**SUBJECT: TURKEY POINT UNITS 3 AND 4 - ISSUANCE OF AMENDMENTS RE:
IMPLEMENTAION OF THE REVISED THERMAL DESIGN PROCEDURE AND STEAM
GENERATOR WATER LEVEL LOW-LOW SETPOINT (TAC NOS. M92208 AND M92209)**

AMENDMENT NO. 183 TO FACILITY OPERATING LICENSE NO. DPR-31-TURKEY POINT UNIT 3
AMENDMENT NO. 177 TO FACILITY OPERATING LICENSE NO. DPR-41-TURKEY POINT UNIT 4

SAFETY EVALUATION BY THE OFFICE OF NUCLEAR REACTOR REGULATION
RELATED TO AMENDMENT NO. 183 TO FACILITY OPERATING LICENSE NO. DPR-31
AND AMENDMENT NO. 177 TO FACILITY OPERATING LICENSE NO. DPR-41

TURKEY POINT UNIT NOS. 3 AND 4

Figure 2.1-1
Reactor Core Safety Limit - Three Loops in
Operation

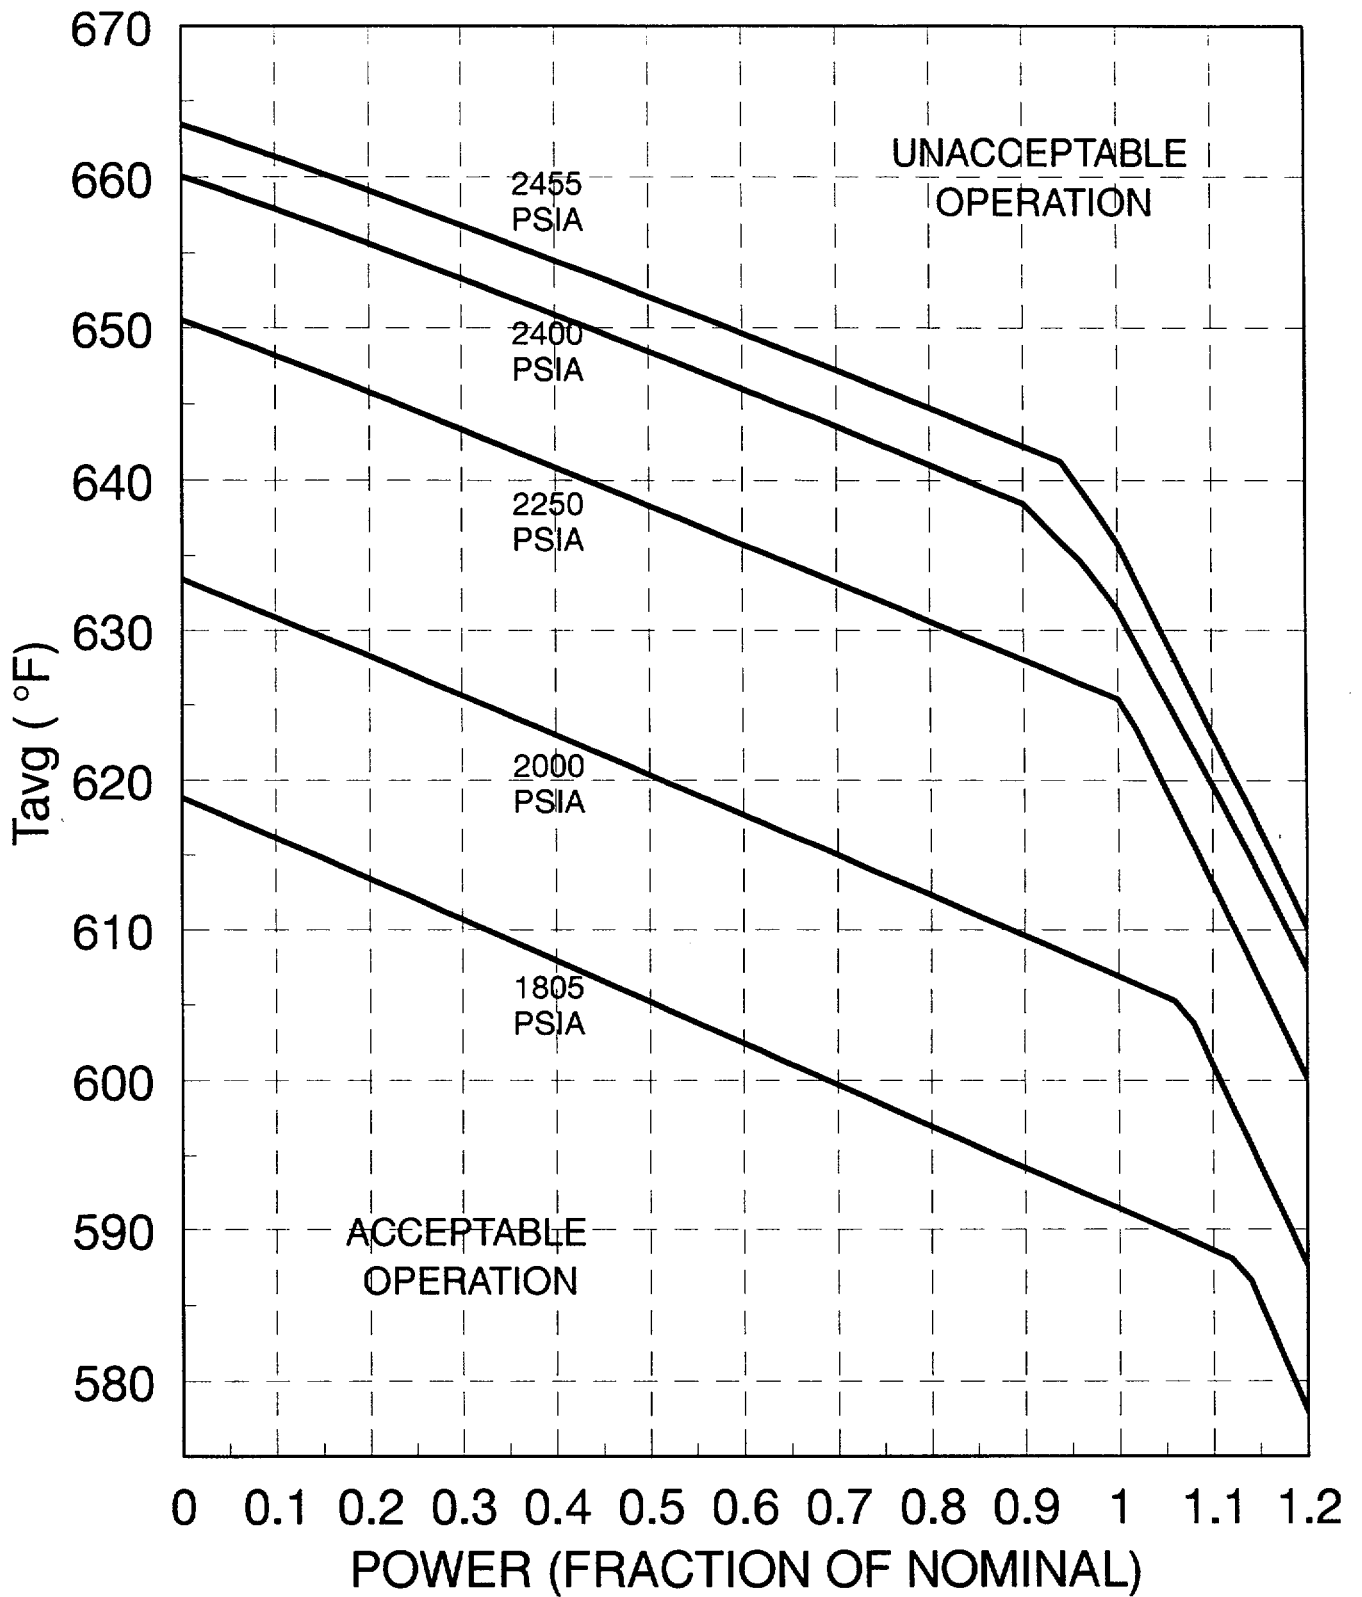
The licensee requested the TS changes regarding the utilization of the RTDP to (1) generate revisions to the core safety limits, namely, TS Figure 2.1-1, and overtemperature and overpower delta T setpoints and associated uncertainties. These revisions will provide an additional operating margin for the core safety limits and are reflected in TS Tables 2.2-1 and 3.3-3 and (2) to determine additional operation margin in the DNB parameters and the loss of flow setpoint identified in TS 3/4.2.5 and 2.2.1.

Revision of the thermal limits is reflected in Figure 2.1-1 of the submittal. These thermal limits were generated by using the RTDP Methodology. The RTDP takes advantage of the conservative use of the statistical combination of values for the reactor power, RCS flow, and temperature and pressure to calculate the DNBR limit. Changes in the hot channel factors and the RCS flow cause the DNB core limits to change. The RTDP methodology is a modification of the methodology defined in WCAP-8567 ("Improved Thermal Design Procedure") and approved by the NRC.

The staff has reviewed FPL's submittal pertaining to the analysis of FPL's core thermal limits utilizing the RTDP methodology. These new limits are reflected in Figure 2.1-1 of their submittal. All the reactor trip setpoints pertaining to overtemperature and overpower delta T were calculated using the RTDP methodology. The staff has previously found use of this methodology acceptable. All the accidents analyzed (rod withdrawal, boron dilution, etc.) were found to meet the acceptance criteria, and they consequently maintain the same margin of safety as before. Therefore, the staff finds the proposed TS changes acceptable.
